BID ADDENDUM NO. 2

Date of Addendum: October 13, 2023
Issued for Bid Date: September 22, 2023
Client Name: Mount Pleasant Central School District
Project Name: 2022 WMS Makerspace and PPS Project
SED Project No.: Westlake Middle and High School: 66-08-01-06-0-005-025, 006-015
MEMASI Project No.: 107-2201
Contracts: Contract No. 1 – General Construction (GC)
Contract No. 2 – Mechanical Construction (MC)
Contract No. 3 – Electrical Construction (EC)
Contract No. 4 – Window Construction Work (WC)

2022 WMS MAKERSPACE AND
PPS PROJECT

ELECTRIC DOMESTIC HOT WATER HEATER DETAIL

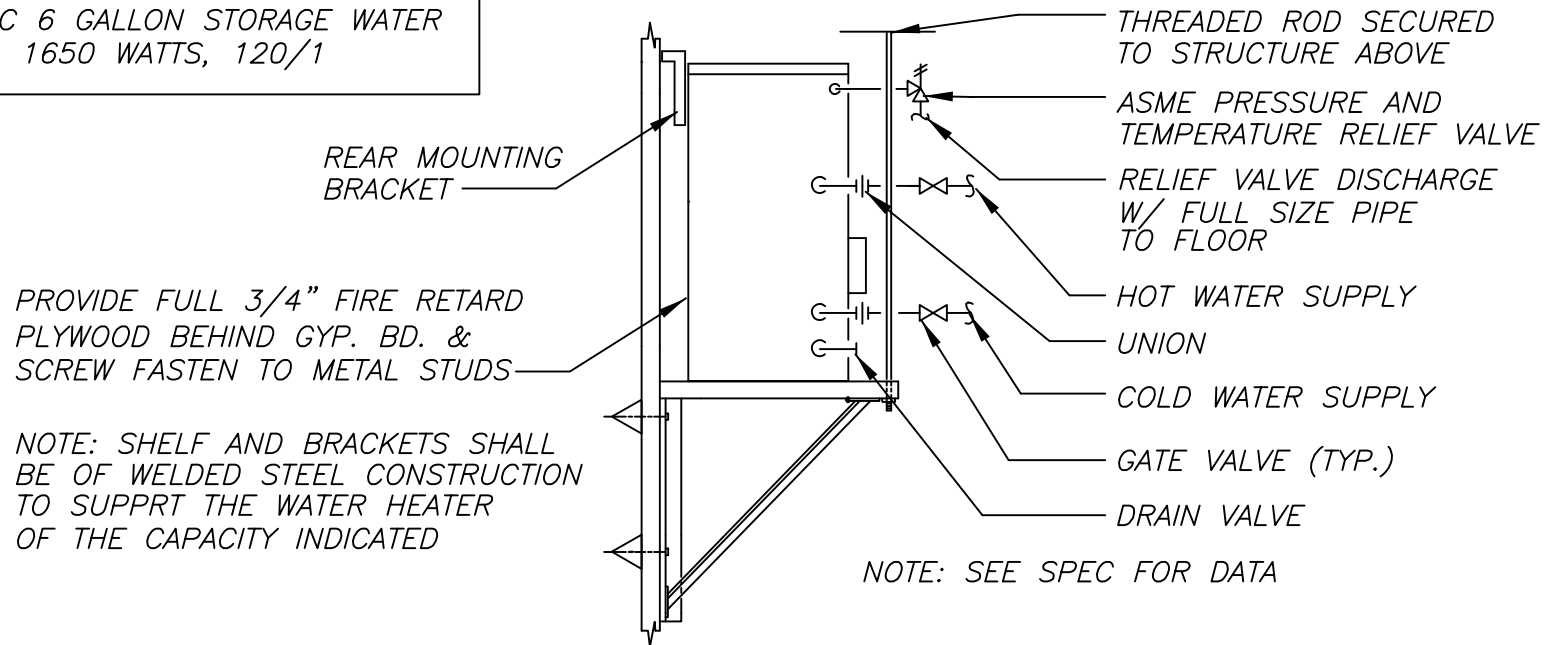
RFI DESCRIPTION: *Drawing P201 – Detail 2 – shows the water closet, lav and hose bibb. There is nothing shown for domestic hot & cold water piping.*

RFI #6 – Please provide a drawing showing route for hot and cold water lines.

Please see the attached sketches.

A.O. SMITH EJC-6
ELECTRIC 6 GALLON STORAGE WATER
HEATER, 1650 WATTS, 120/1
